November 19, 2019

Project 171.05027.008

Re: Nordic Aquafarms, Inc
Request for Additional Information (2)
File No. NAE-2019-01481

CS101 Intake and Discharge Piping Plans

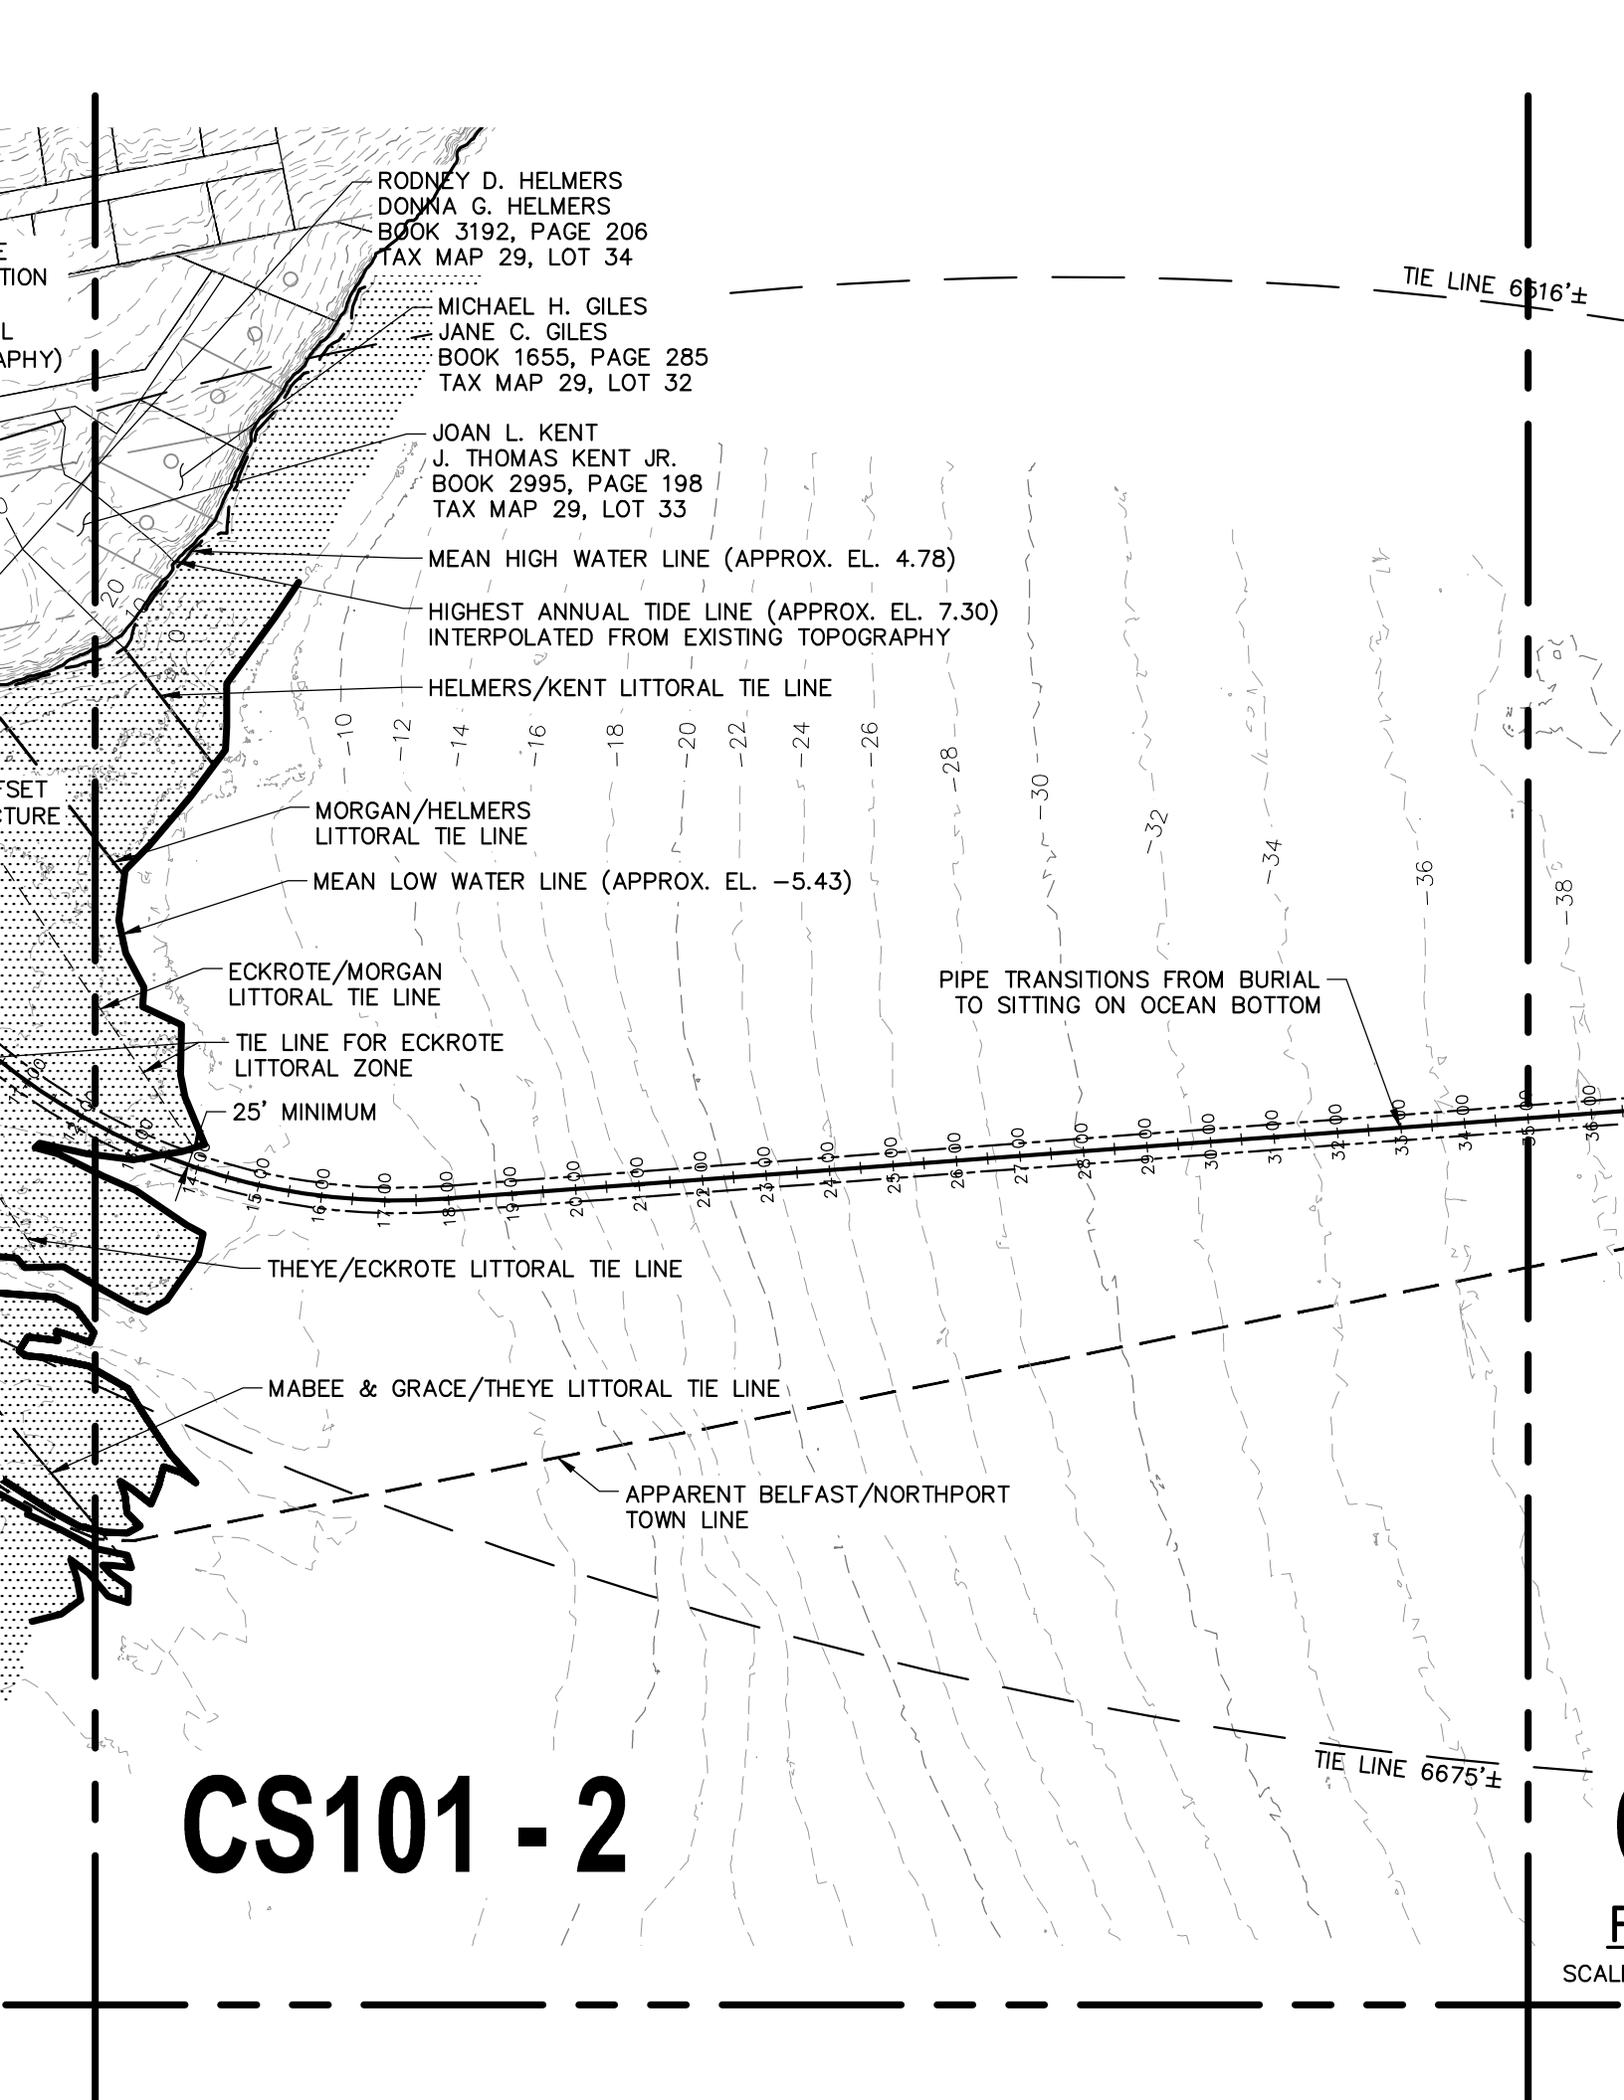
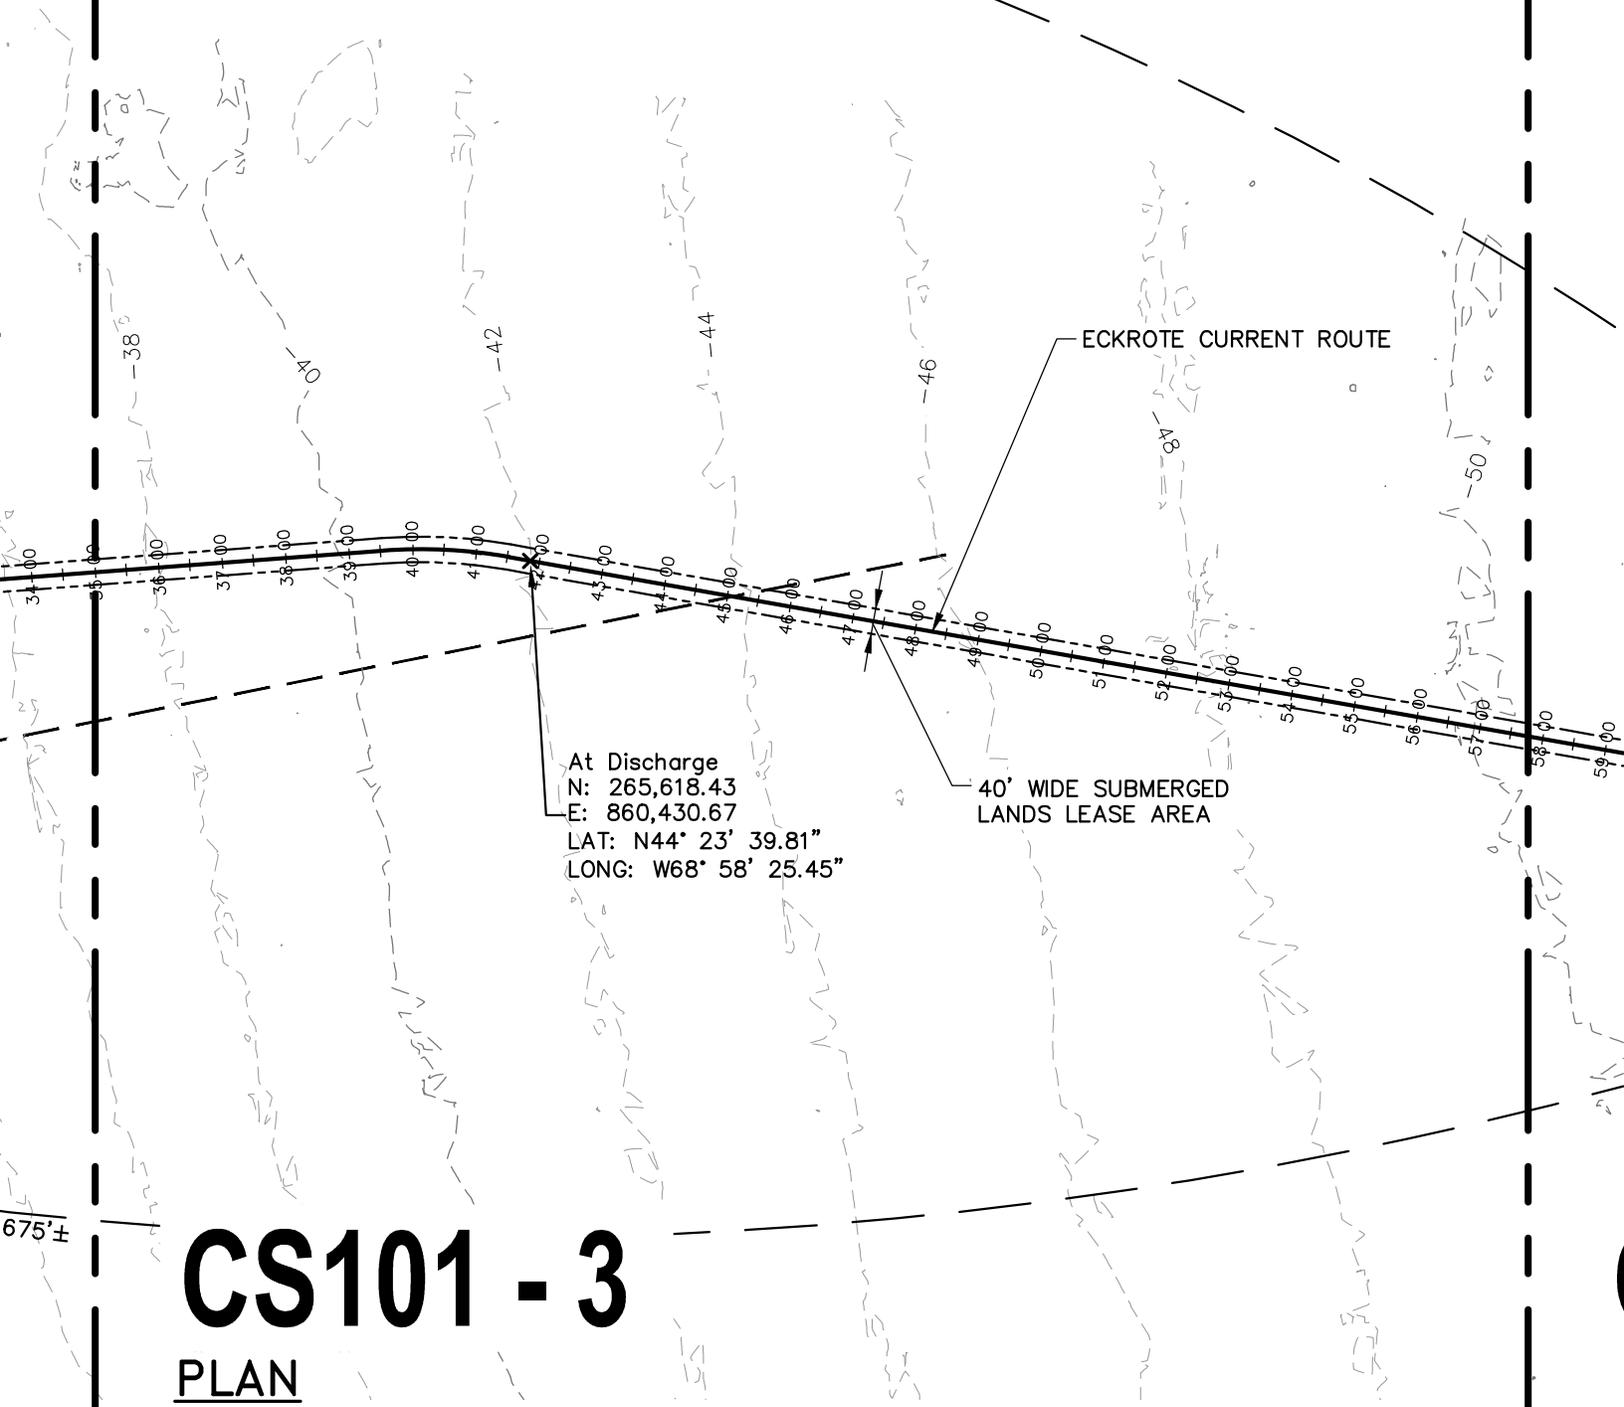
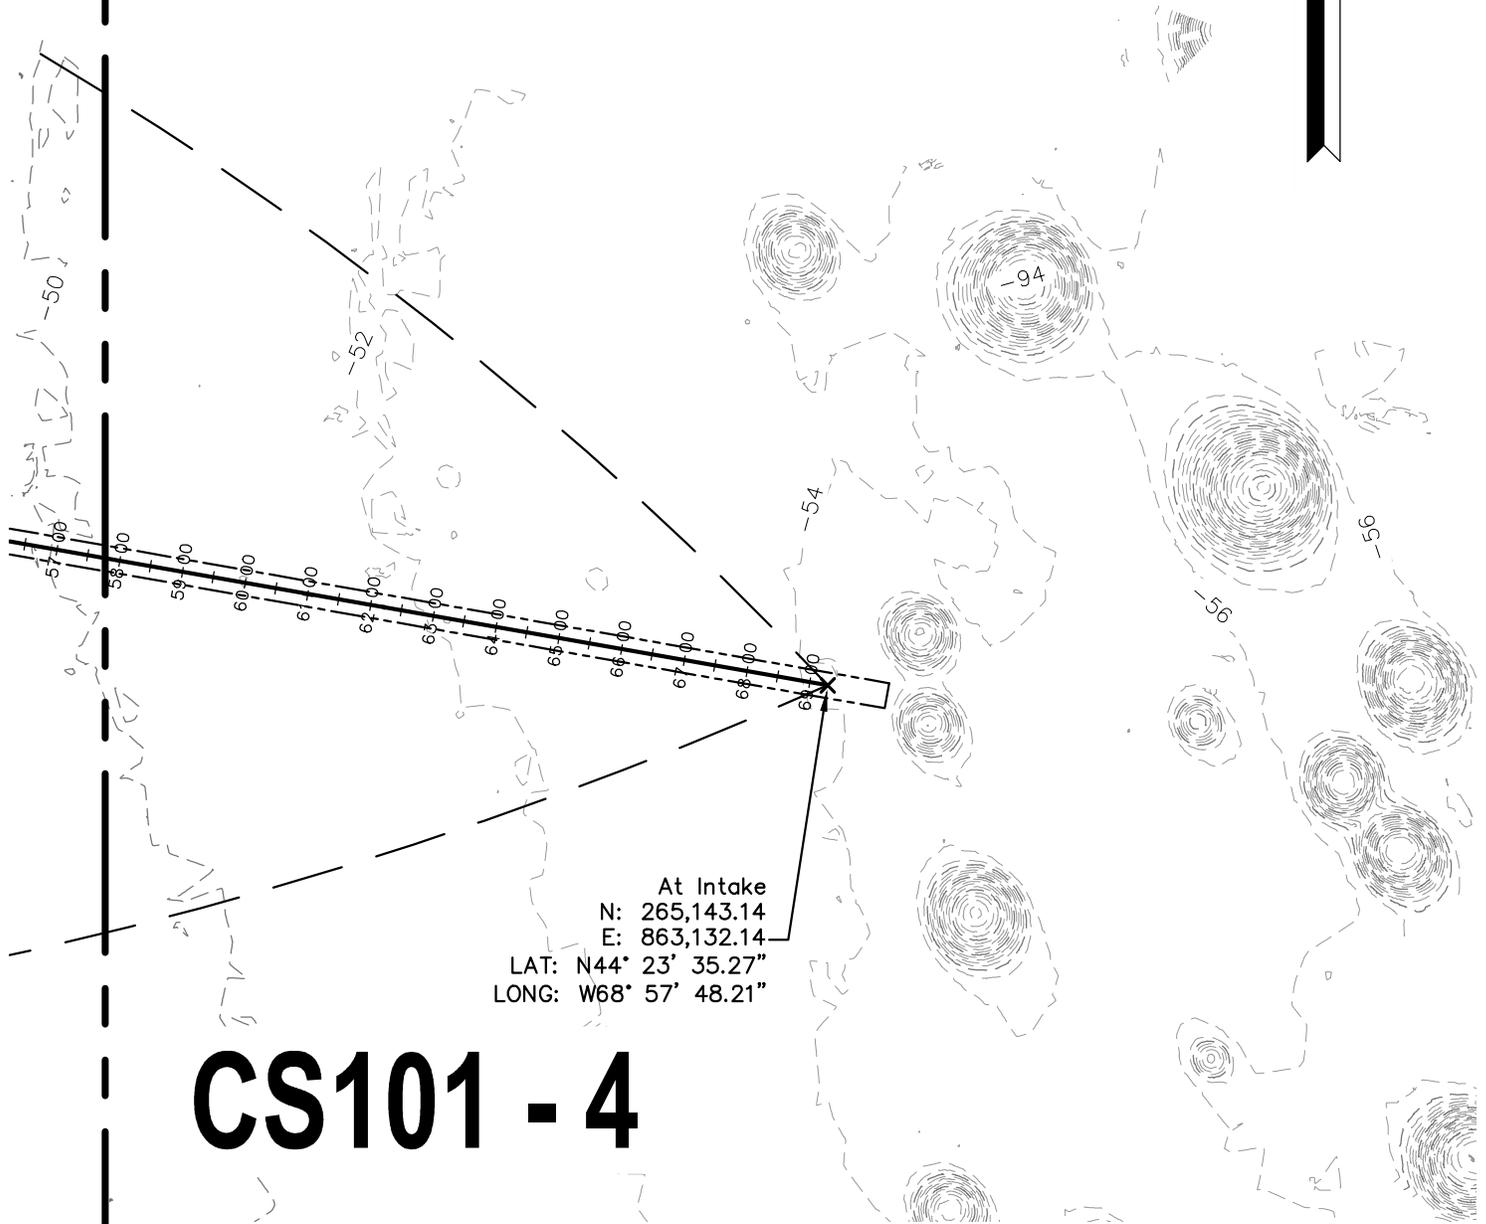
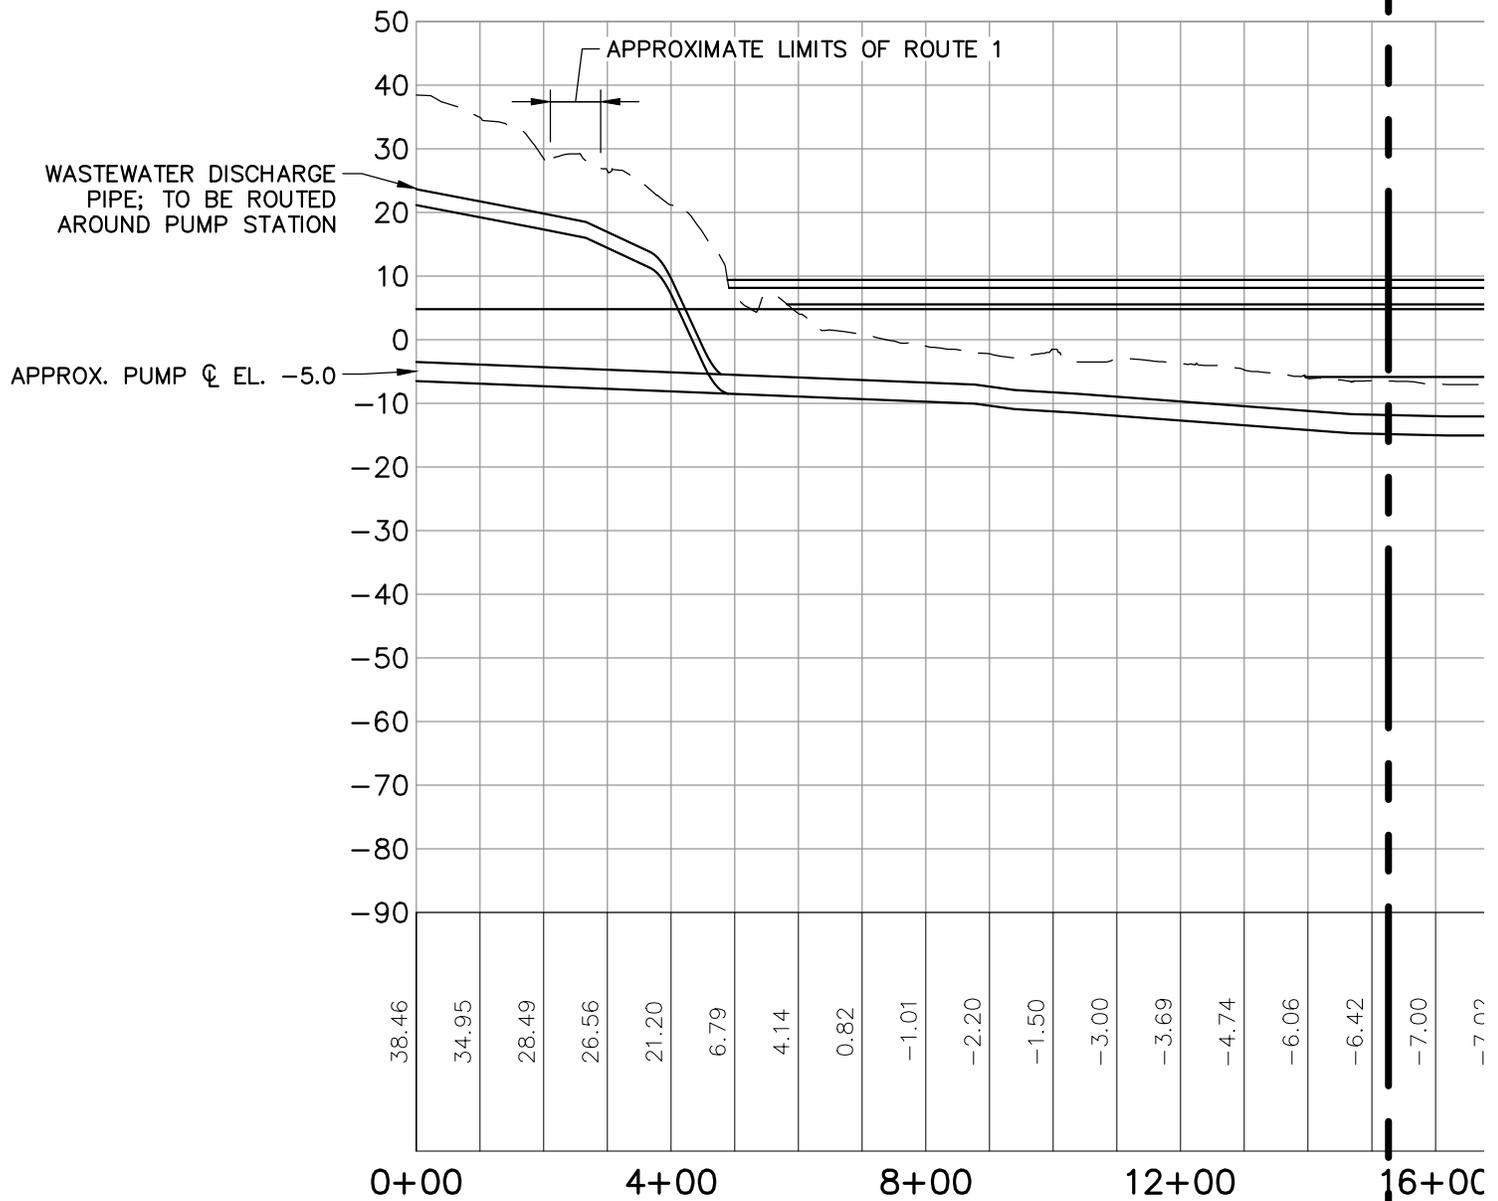
6. Attachment D. Sheet CS-101. I need a reduced 8 ½ x 11 version of this plan. Given the length this can be on 2 sheets, one of the Plan views with a match line and Cross Section with a match line or both views with a match line. Like Sheet 2 of 2 (Item 4) this should also show the High Tide Line along the shore.

The reduced plan is attached as Attachment 6, which shows the High Tide Line as requested. Note that construction mats are now shown on the drawing for work to be conducted in the intertidal zone. The construction mats will be placed in a linear fashion along the planned trench, and removed when not in use,
